Staff Report City of Manhattan Beach

SUBJECT: Uphold the Planning Commission Denial of a Coastal Development Permit for

Extended Concrete Pads on the Beach/Bike Path Between 27th Street and 28th Street

A RESOLUTION OF THE PLANNING COMMISSION OF THE CITY OF MANHATTAN BEACH DENYING A COASTAL DEVELOPMENT PERMIT AMENDMENT TO ALLOW ENLARGED CONCRETE SURFACE PADS FOR A STORM DRAIN LOW FLOW DIVERSION PROJECT UNDER THE PUBLIC BEACH BETWEEN 27TH STREET AND 28TH STREET (Los Angeles County Public Works)

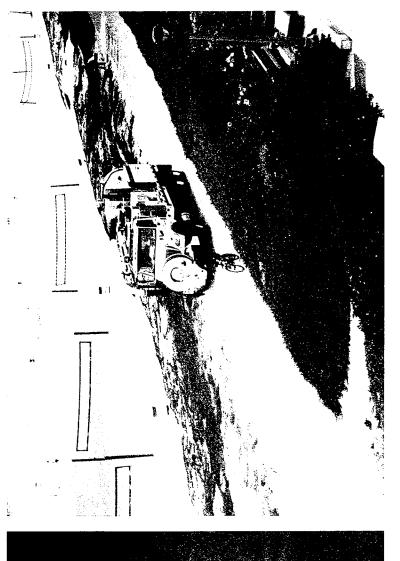
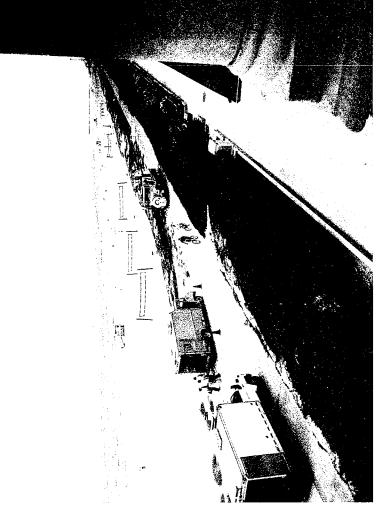
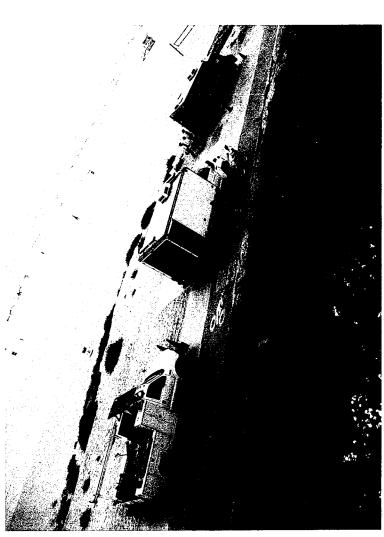
Second, attached please see three photographs of the actual County Vactor truck, along with three other trucks, parked at the 28th Street site. As can be seen: 1) The Vactor truck can be and actually is parked on the bike path itself so as to allow one lane of bike path traffic to proceed; 2) No flagman or traffic control is apparently needed or provided; 3) The County does not actually use the pads for the Vactor truck- indeed only a smaller one of the four trucks used the pads and clearly not by necessity; and 4) Once again, the County clearly does not regard blockage of one lane of the bike path as any sort of problem.

Additionally, adequate truck access to the area exists. There is street access to the bike path at Marine Ave. and at the El Porto parking lot. Yet, the Vactor trucks have actually been witnessed proceeding Northbound on the bike path <u>in reverse</u> to exit the path, even with the enlarged pads in place, and even though an exit to the South at Marine Street is available.

Third, even assuming parking pads were necessary, which as shown they are not, they are far larger than common sense dictates. According to Vactor, the 2110 is 31.5 feet and the 2115 is 36 feet overall in length. The 28th Street pad, which the County asserts is "necessary," now measures 85 feet in length. However, 42 feet is to the South of the main 7-foot long manhole and 36 feet extends to the North. Assuming the manhole must be open to work on it, it is difficult to imagine how the Vactor truck could even make use of both sides, let alone that they are somehow necessary.

In sum, the photographs of actual practices engaged in by the County establish beyond question that other alternatives exist to either closing the path completely or constructing enlarged parking pads on the beach. As such, it cannot credibly or in good faith be asserted that the illegal enlarged pads are "necessary" for the maintenance of the storm drain diversion installation. Moreover, given that the asserted maintenance will occur only twice per year, even if some additional inconvenience is involved- which appears not to be the case- it would be outweighed by the interest in preserving the beach sand area in its natural state. It is respectfully submitted that the application should be denied and the applicant directed to bring the installation into conformance with the approved plans and permit.

Figure 3 – As-built condition of Project No. 286

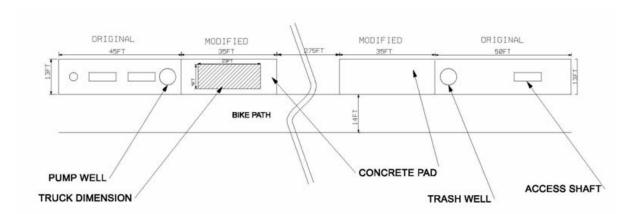
Due to the heavy pedestrian traffic on the Strand (bicyclists, runners, rollerbladers, etc. – See Appendix for traffic counts) it was determined based on field inspection that a staging area for maintenance crews would be needed to prevent any obstruction of the Strand. DPW has deemed any obstructions to the Strand as a hazard to public safety therefore concrete pads were constructed around the Low Flow Diversion units.

If the additional concrete pads did not exist this would cause a safety hazard to both pedestrians and maintenance crews. Based on the suggestion from the Manhattan Beach Planning Commissioners to have the pads removed, a test was setup on August 22, 2007 to determine if obstructing The Strand could be a viable option to the construction of concrete pads. The area of work was sectioned off with traffic safety cones and warning signs were posted requiring bicyclists to walk their bikes in the vicinity of the maintenance. Unfortunately, many bicyclists did not complied with these rules — riding through the coned areas with a few even confronting workers about the obstruction. Because of the confined spaces and use of heavy equipment, the safety of the crews is compromised when they are not allowed to fully concentrate on the task at hand.

Figure 6 – Minimum Length of Concrete Pads

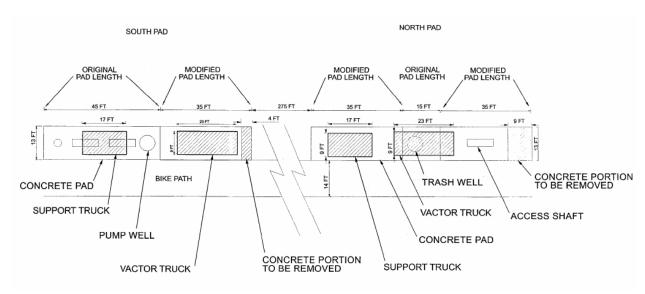
The concrete pad on 28th Street and The Strand is 13 feet by 85 feet and the pad on 27th and The Strand is 13 feet by 80 feet. Upon further review of these dimensions, it has been determined that the pads on 27th and 28th can be reduced by 4 and 9 feet respectively. This is the minimum length required to safely maneuver and operate the vacuum truck and its support vehicle. This minimum length was determined by placing both vehicles end-to-end and measuring the excess concrete on the pads. If deemed necessary, those excess portions of concrete can be removed.

In response to a question from Commissioner Lesser, **Mr. Burton** stated that they are proposing to reduce the pad lengths by 4 feet for the pad adjacent to 27^{th} Street and 9 feet for the pad adjacent to 28^{th} Street, resulting in each pad being approximately 13 feet by 76 feet.
